**COUNTRY CLUB DEVELOPMENT**

**CONCEPTUAL GRADING AND DRAINAGE PLAN**

# TEMPORARY DRAINAGE CERTIFICATION

# **EASTERN BUILDING DRAINAGE CERTIFICATION**

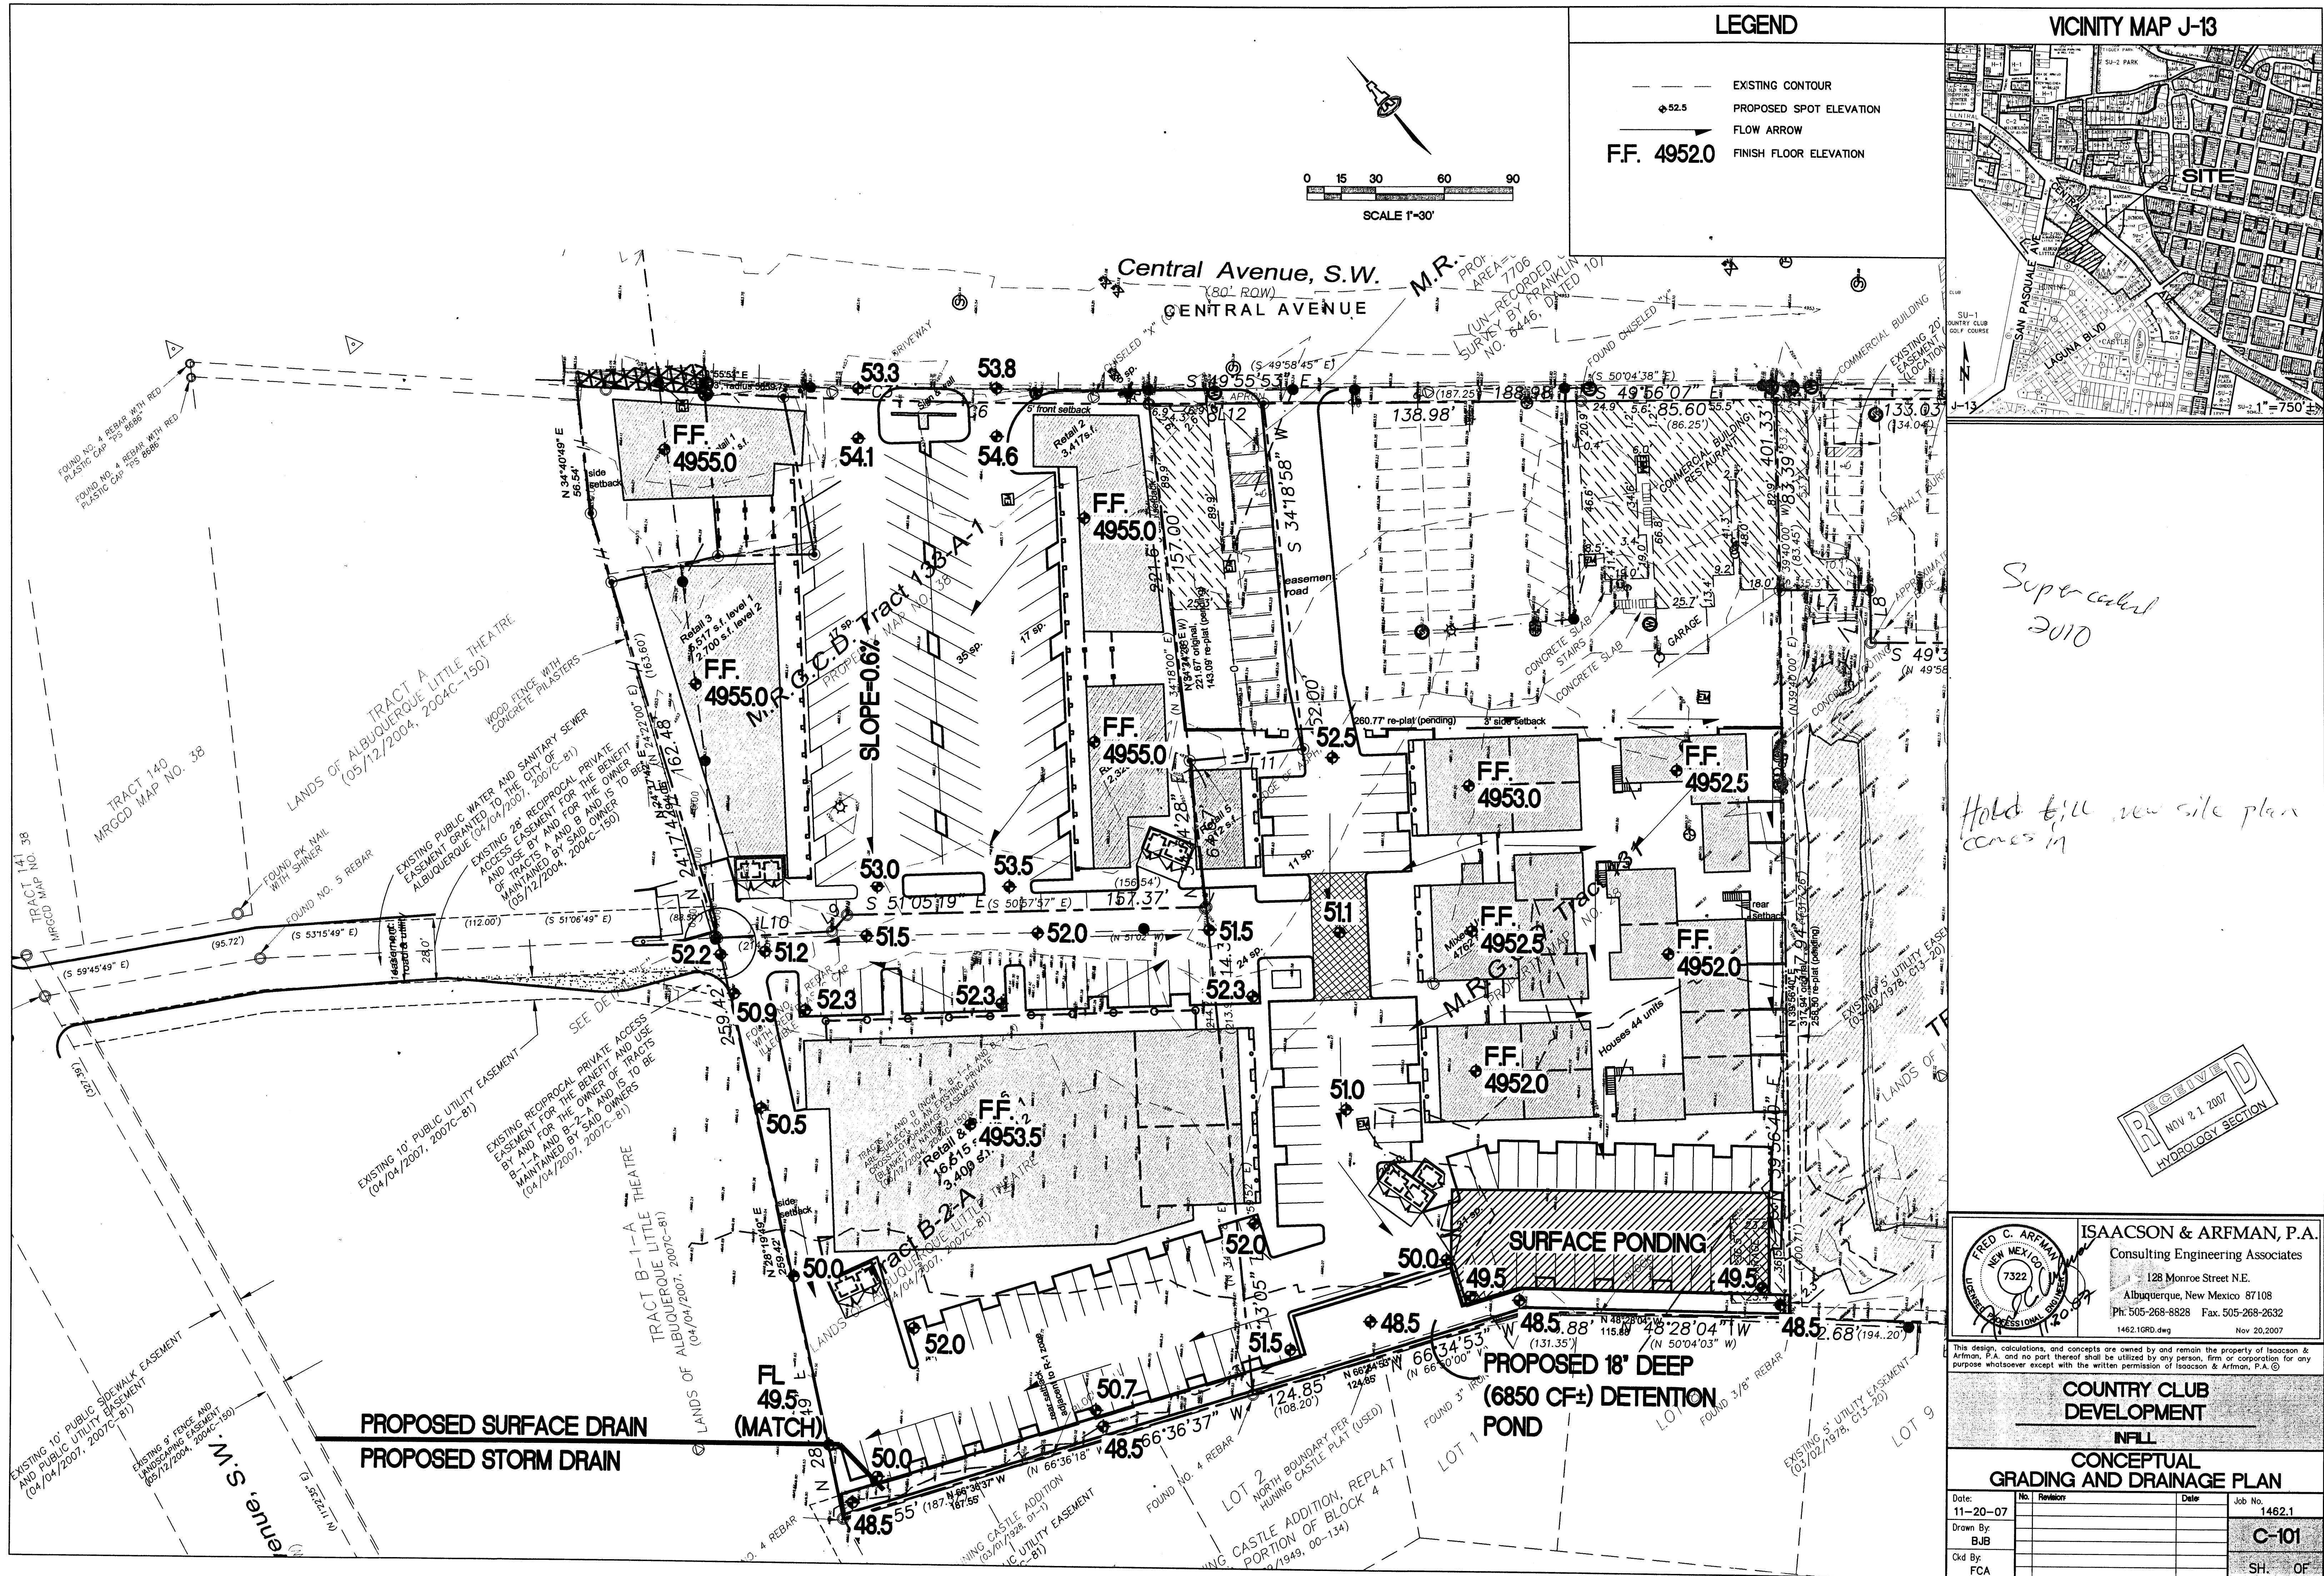
- The concrete alley gutter on the SW corner was changed to a Phase 2 item, at which time new asphalt grades to the south will allow for improved drainage of the alley gutter. Existing asphalt grades currently drain.
- The western existing building is still under reconstruction. The adjoining private sidewalks, roof drains, and patio are not completed, and must be complete prior to final certificate of occupancy. They are not vital to the function of the eastern "Aveda" building, so shouldn't impede temporary CO.
- The roof drains on the south side of the Aveda building were changed to discharge across the sidewalk, rather than through 4" PVC pipes under the sidewalk. This change is acceptable.
- The sidewalk on the east side of the Aveda building isn't complete, and the trench drain isn't installed in the sidewalk. This work needs to be complete prior to final CO.

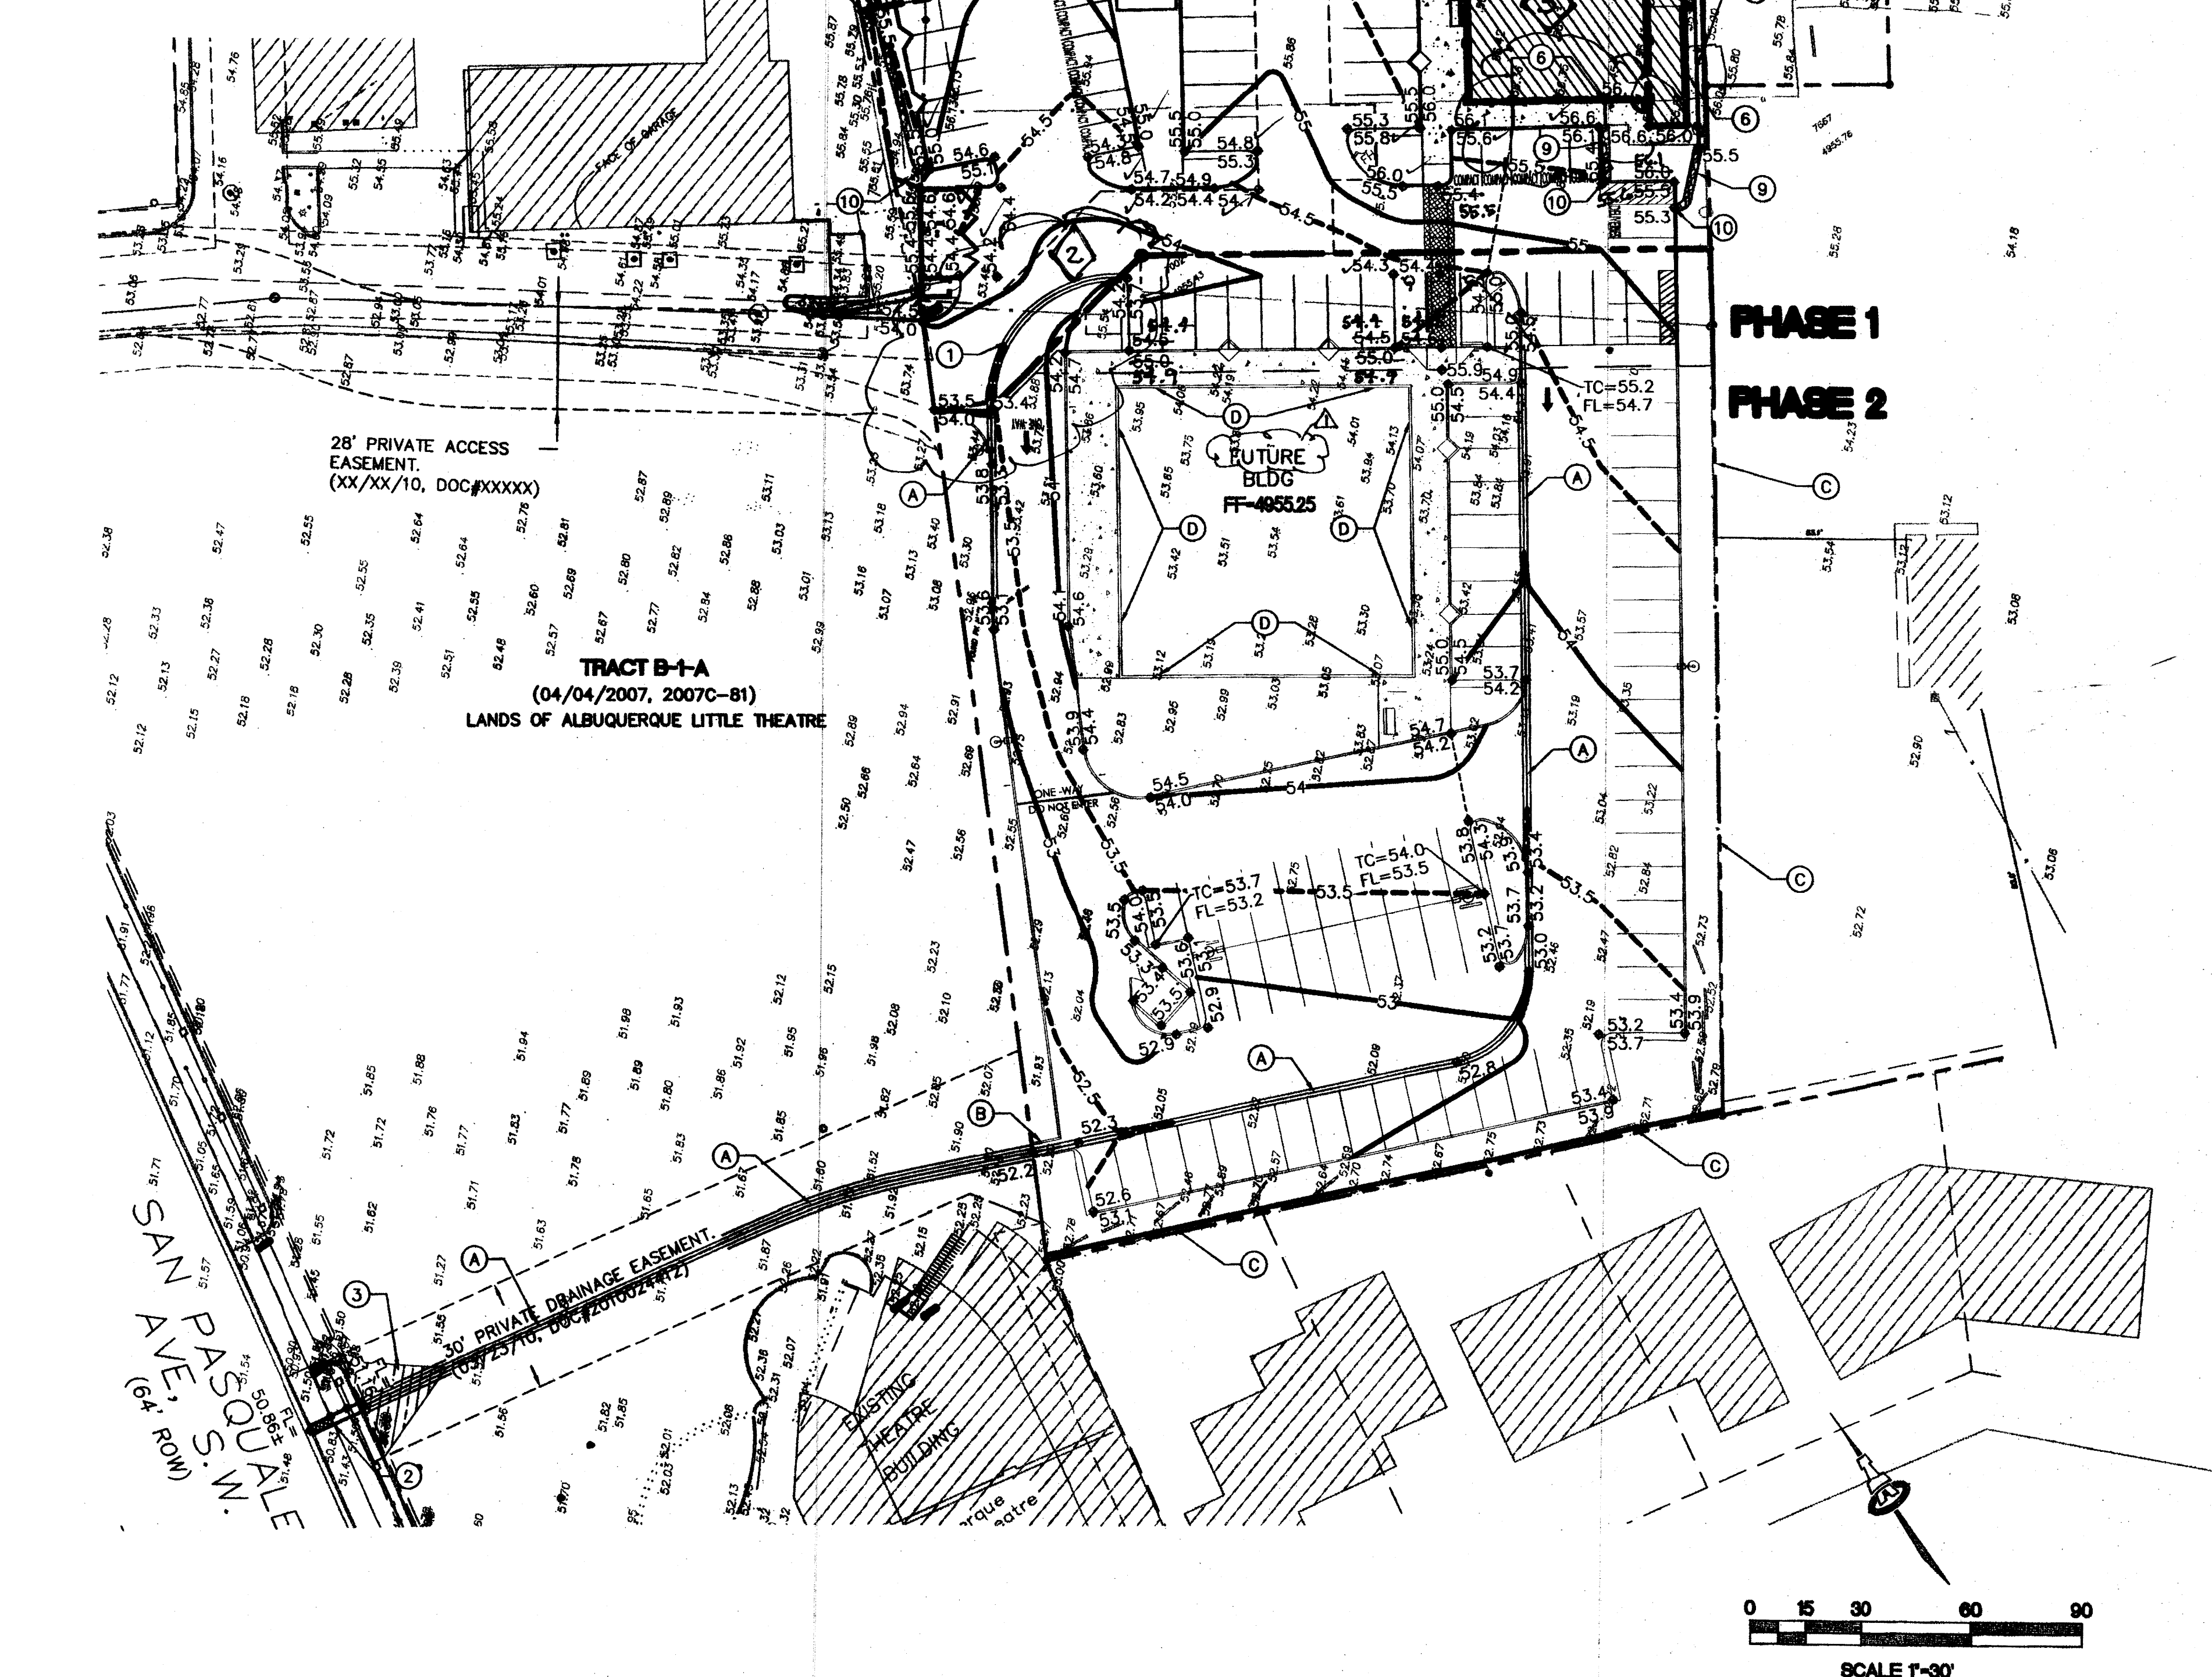
- The westerly existing building is still under reconstruction. The adjoining private sidewalks, roof drains, and patio are not completed, and must be complete prior to final certificate of occupancy. They are not vital to the function of the easterly "Aveda" building, so shouldn't impede the CO for the easterly building.
- The concrete alley gutter on the SW corner was changed to a Phase 2 item, at which time new asphalt grades to the south will allow for improved drainage of the valley gutter. The asphalt will be reworked to direct the drainage south prior to CO for the easterly building.
- The roof drains on the south side of the Aveda building were changed to discharge across the sidewalk, rather than through 4" PVC pipes under the sidewalk. This change is acceptable.
